SUBJECT: Forwards potential finding repts processed & classified by
 GA CO as invalid, observation or out of scope.

Subject: Docket Nos. 50-361 and 50-362
San Onofre Nuclear Generating Station
Units 2 and 3

Enclosed are sixty-three (63) copies of the Potential Finding Reports (PFR) which have been processed and classified by General Atomic as follows:

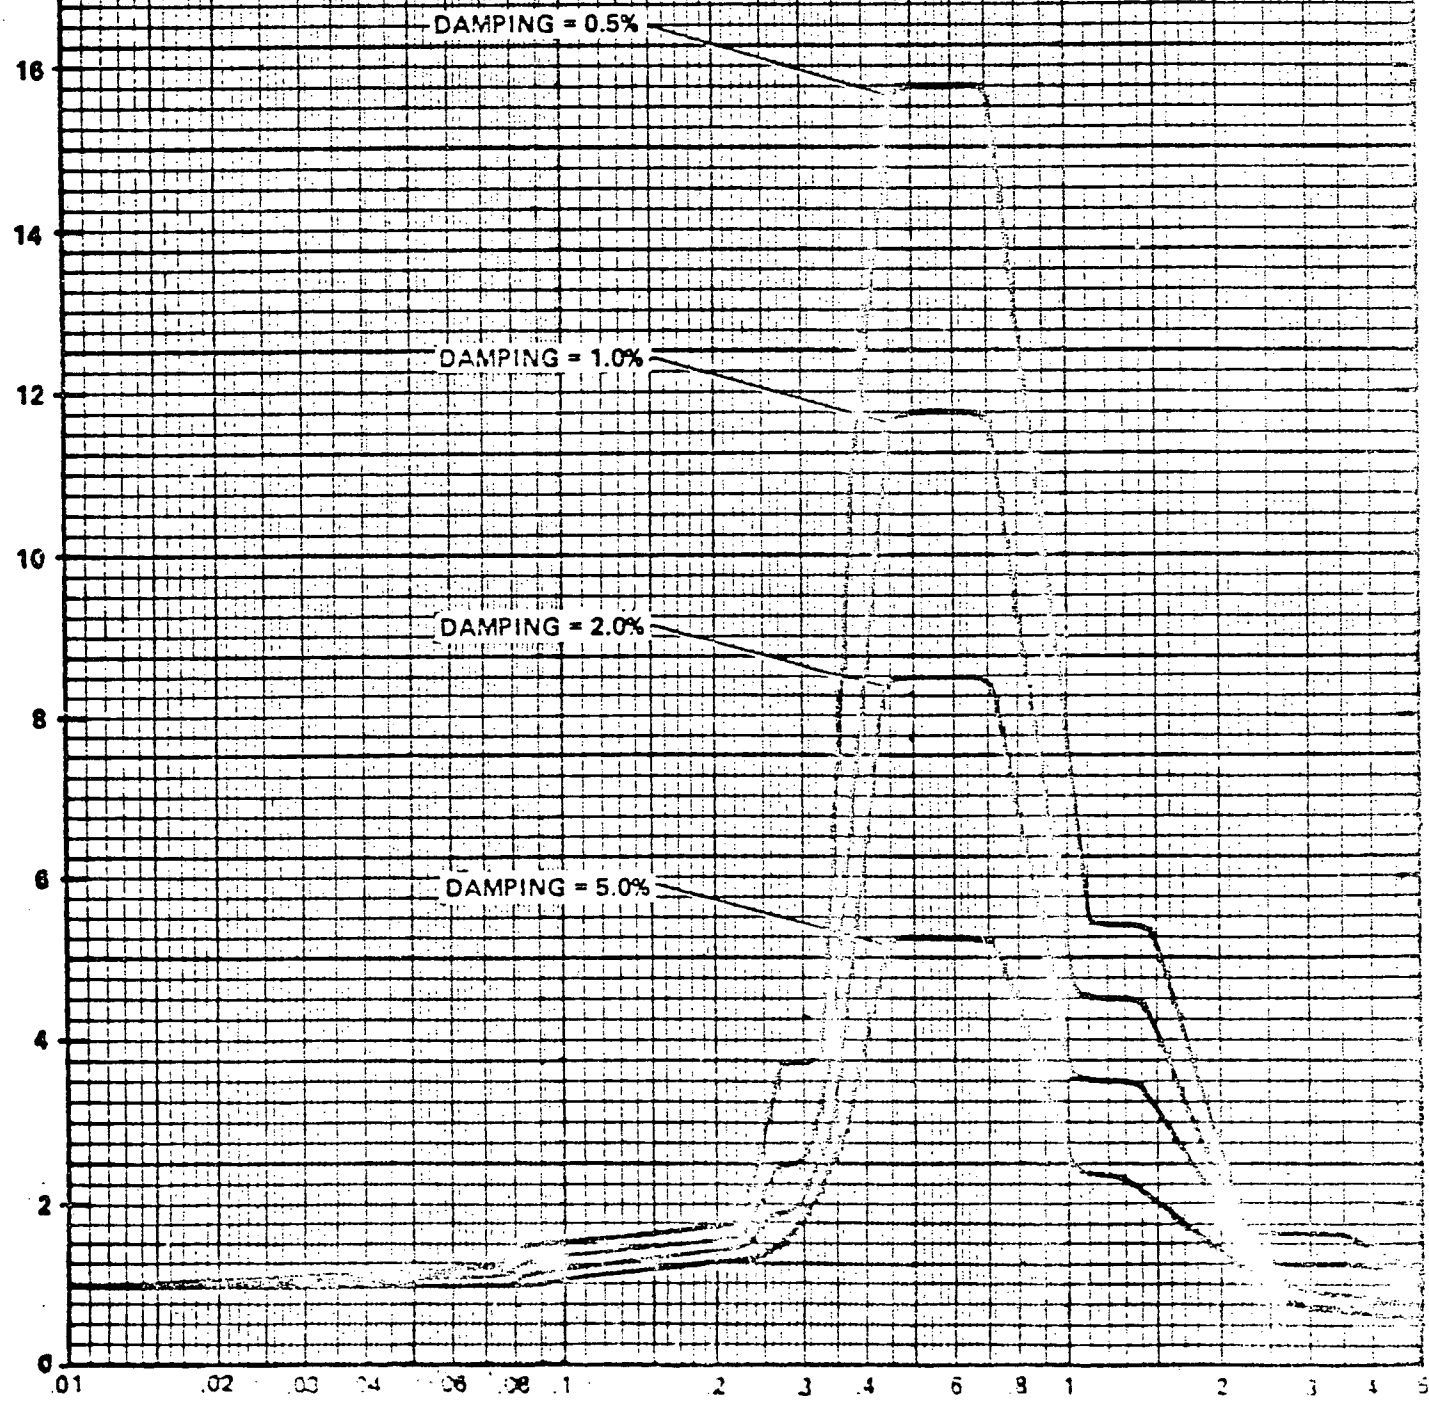
DESCRIPTION OF POTENTIAL FINDING: The seismic Response Spectra given for MCCs mounted
at Grade Level are marked "Preliminary for bid purposes only". There is no
indication that "Final" copies were sent to the vendor or that the "preliminary"
curves were eliminated.

1. The seismic qualification report, Log S023-302-4-2-55, identifies the response spectra used for the qualification of equipment at elevation 50'. The preliminary report with response spectra at grade was for bid purposes only, and it was not utilized in the qualification tests.

2. The Nodes 9 and 9A represent the floor at elevation 50'-0 of the Control Area of the Auxiliary Building in the mathematical lumped parameter model of the building shown in Figure 3.7-19 of the FSAR. The horizontal response spectra curves of SK-S-701 and SK-S-725 for DBE and OBE events, respectively, are applicable to any location on elevation 50' (Node 9) and envelope the maximum horizontal acceleration response along either principal horizontal directions. The vertical response spectra curves of SK-S-737 and SK-S-739 for DBE and OBE events, respectively, are applicable to the Control Area of the Auxiliary Building where the slabs are supported by structural steel columns and beam framing, as designated by Node 9A. The lumped parameter model approach with inclusion of the steel framing, together with the enveloping techniques used, result in conservative response spectra curves.

The horizontal response spectra at elevation 50'-0 is generically given by SK-S-701 and -725 for all areas of the concrete floor slab since in the horizontal direction the floor is a rigid diaphragm.

ITEM 2: AFTER EXAMINATION OF THE COMPLETE SET OF RESPONSE SPECTRA FOR THE 50 FT. LEVEL IN THE AUXILIARY BLDG., WE NOW AGREE THAT THE RESPONSE SPECTRA INCLUDED WITH SPECIFICATION ARE CONSERVATIVE.

PFR-0058
2/3/82 JOC

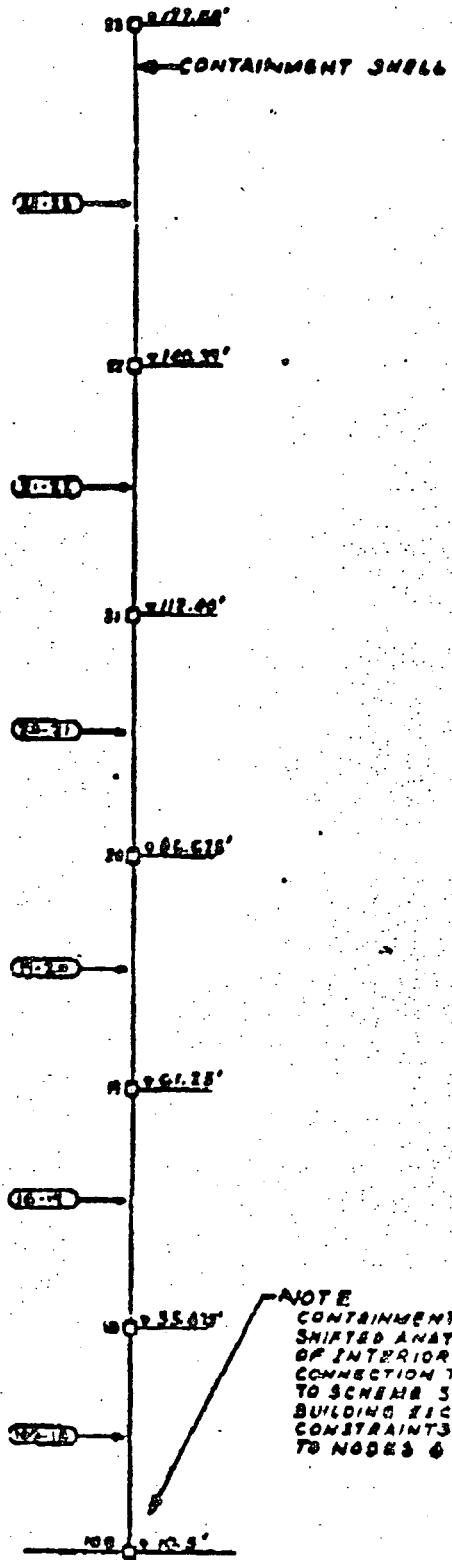
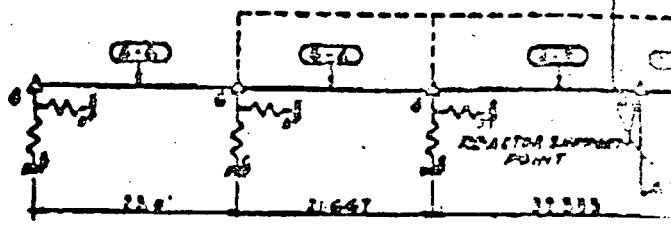
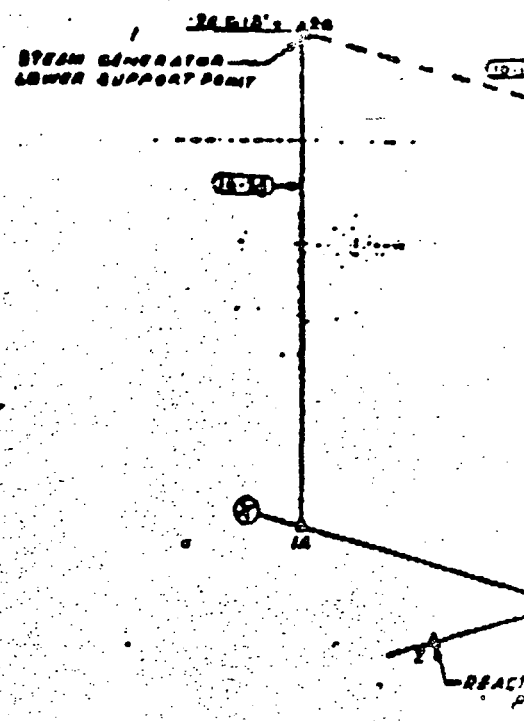
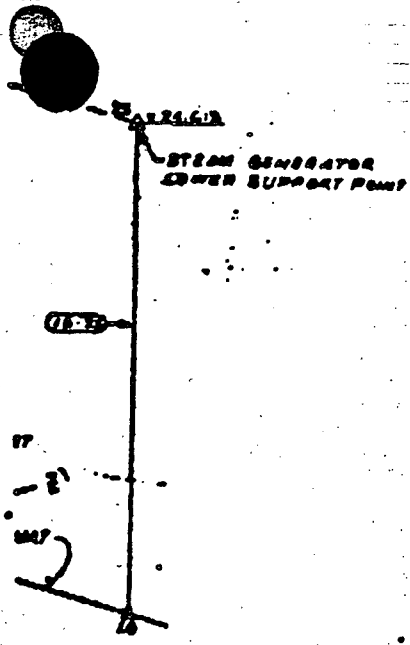
The finding is correct, but the deviation is limited to an improper designation of I_1 instead of the correct I_2 for elements 10A-10, 10-11, 11-12, 12-13 and 13-14, as tabulated sheet 3, Figure A-6. For these elements $I_1 = I_2$, and the correct values were used for I_1 and I_2 as indicated in the attached sheet of the computer listing of input.
